1st Further Information

Proposed Temporary Warehouse (Excluding Dangerous Goods Godown)
with Ancillary Facilities for a Period of 3 Years in "Open Storage" and "Recreation" Zones,
Various Lots in D.D. 117 and Adjoining Government Land, Tai Tong, Yuen Long, New Territories

(S.16 Planning Application No. A/YL-TT/635)

Responses-to-Comments

Appendix B: Outside Catchment Plan

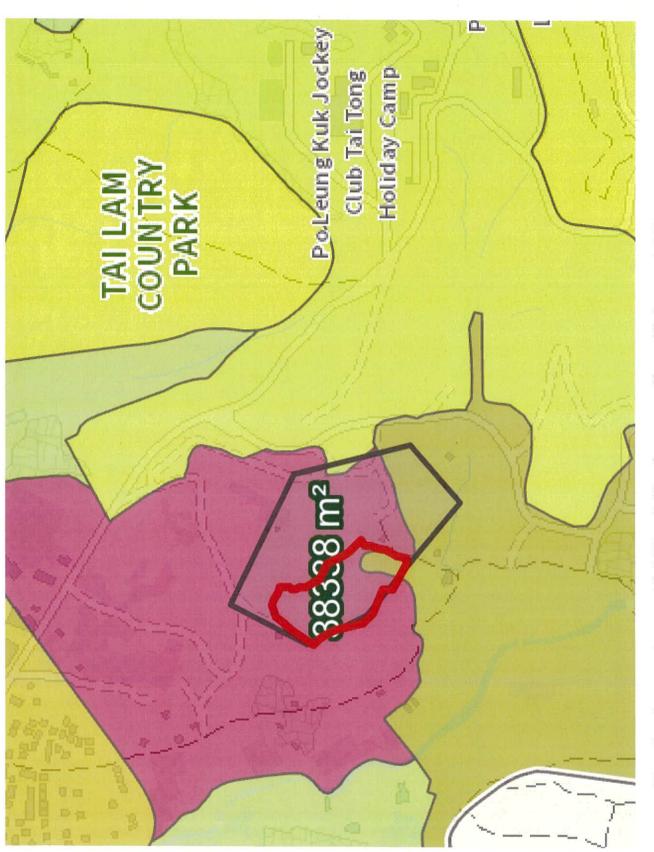
- 3. Comments of District Planning Officer, Tuen Mun and Yuen Long West, Planning Department (DPO/TMYLW, PlanD)
- (a) Please clarify the portion of "OS" zone and "REC" zone.

Majority of the Site (i.e. 9,083m², about 88% of the Site) falls within an area zoned as

"Open Storage" zone and the remaining
	portion of the Site (i.e. 1,230m², about 12%
	of the Site) falls within "Recreation" zone
	(Plan 1).
=

Appendix C: Drainage layout plan

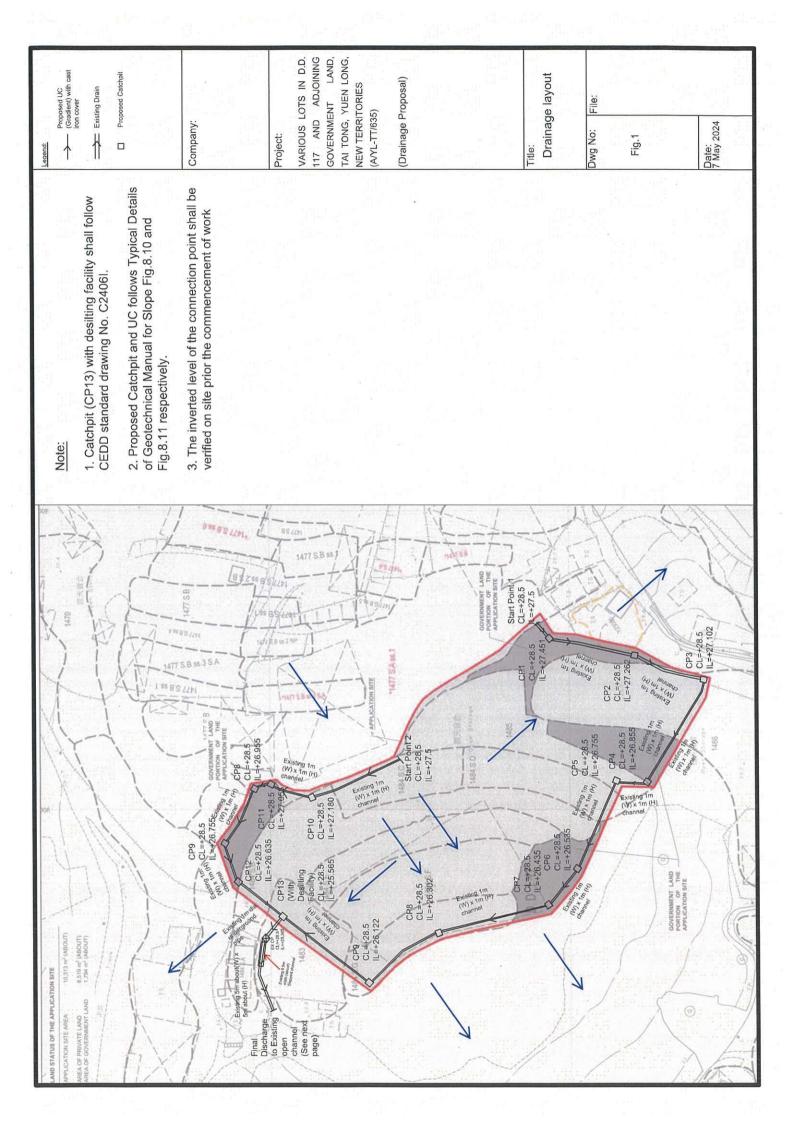
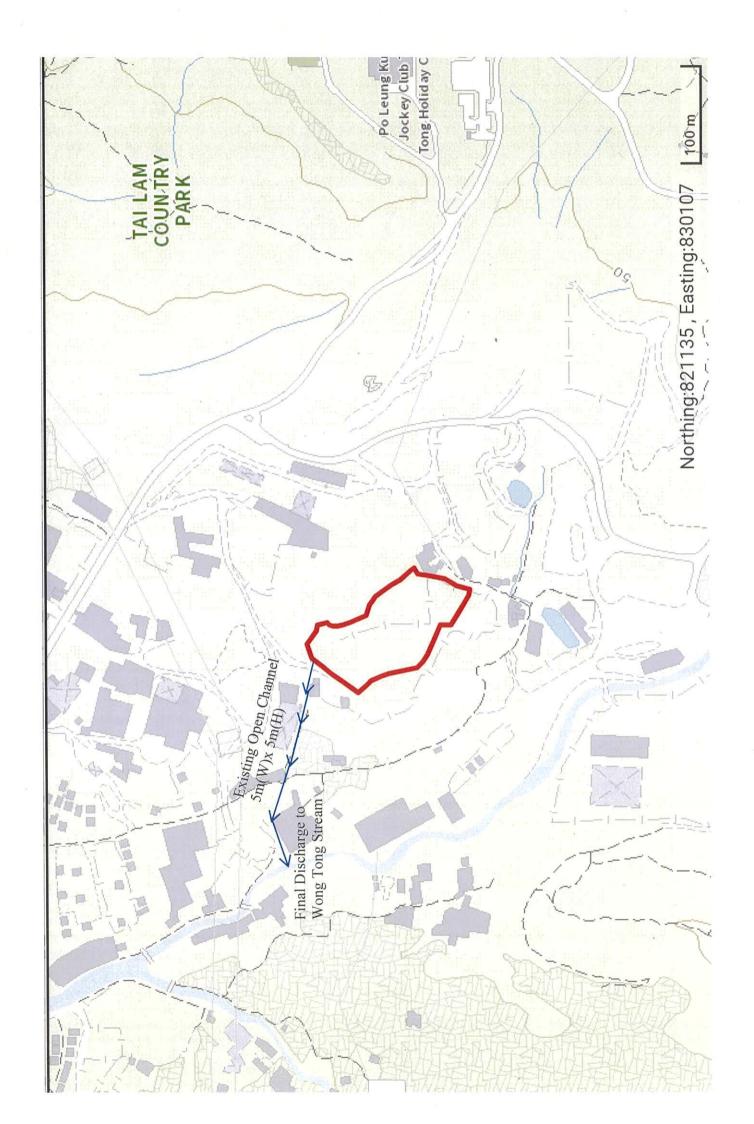
(a) Drainage Impact Assessment is required for this application.

The applicant has submitted a drainage impact assessment to mitigate the potential drainage impact caused by the proposed development, in order to support the application (Annex I).
